# DESIGN SCENE

OFFICE OF PROJECT MANAGEMENT & TECHNICAL SUPPORT

PROJECT DESIGN SERVICES UNIT

June 2014 - Page 1

## Chapter 14 – Impact Attenuators

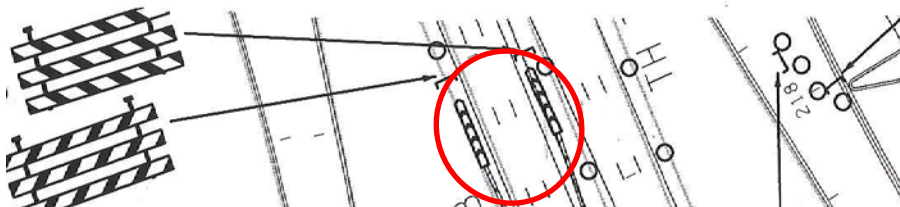
In order to avoid external conflicts and maintain consistency within MnDOT, we will be changing how we call out temporary and permanent impact attenuators on our traffic control plans.

We will be specifying whether they are TL3's or TL2's (test level's) instead of posted speed limits.

All Temporary Impact Attenuators that are to be placed on roads with the speeds of 50 mph or greater will now be TL3 and those that are 45 mph or less shall be TL2.

These will be noted on our Pay Item Tabulation sheets like we have been doing. If the project requires both TL3 and TL2 attenuation, then they should be labeled on the plan sheets for clarification.

Example: Different test levels...

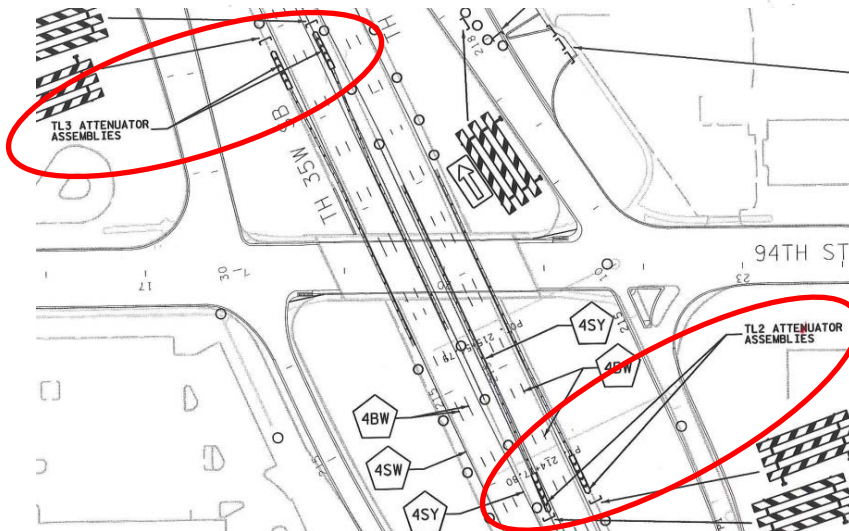
- (1) 2-TL2, 2-TL3 ASSEMBLIES
- (2) 20 WHITE, 20 YELLOW- ALL ONE WAY
- (3) 3052' 4" SOLID LINE WHITE, 840' 4" BROKEN LINE WHITE, 1906' SOLID LINE YELLOW

**Need to label all attenuators as to what level they are.**

## Chapter 14 – Cable Line Post

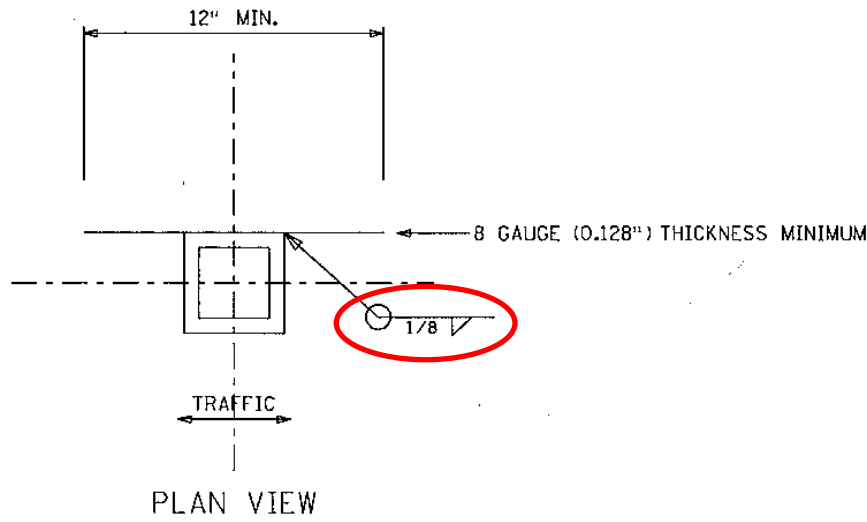
We have new design detail for High Tension Cable Line Post / Steel Socket Foundation with revised date 5/15/2014. The new detail is a change for the welding from staggered to all around welding on the line post and soil plate. The new projects should use the new detail from now on. It can be found in ProjectWise under OTS-DesignStandards-DesignDetails-htcb\_dd.dgn

**Make sure that the detail you use shows this weld.**
